EVS GTR – TF3 JRC's opinion on "30 minute observation period"

12 November 2015

Rescue time

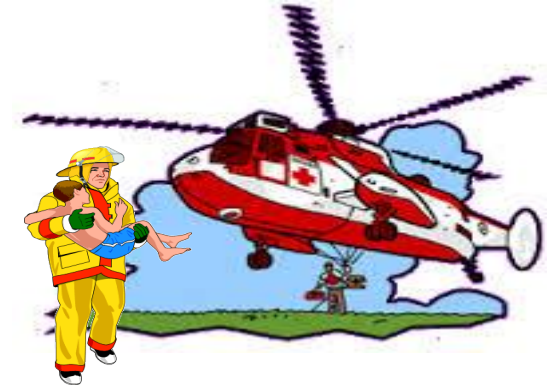
Recently data on average rescue time became available indicating that **'Crash to Accommodation' time in an automotive accident – potential exposure time – often approaches 60 minutes**

Study from Japan Automotive Research Institute (JARI) and Japan Automotive Manufacturers Association (JAMA)*:

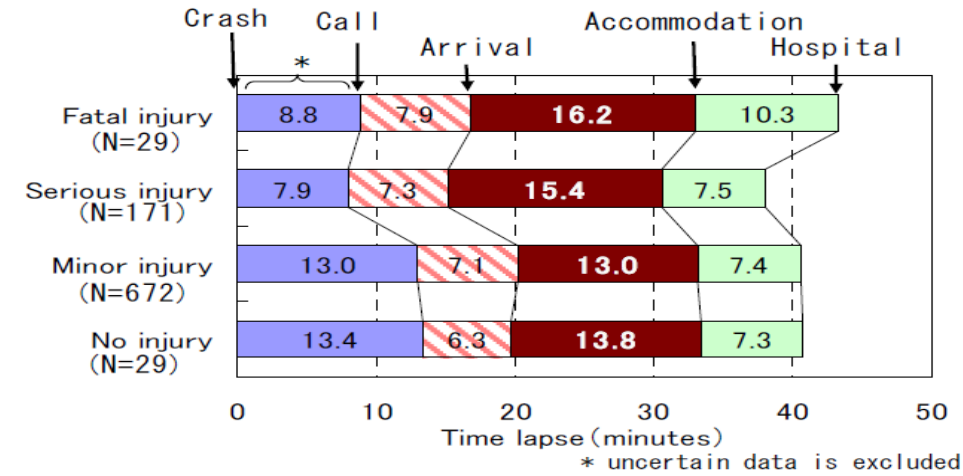
- Various crash scenarios are considered - among passenger cars as well as involving heavier vehicles (trucks)
- Statistical analysis of the 1996-2006 field data in Japan shows that:
 - the average "Crash" – "Accommodation" time often significantly exceeds 30 minutes
 - especially when more than 1 occupant is to be rescued
 - and/or when a truck is involved
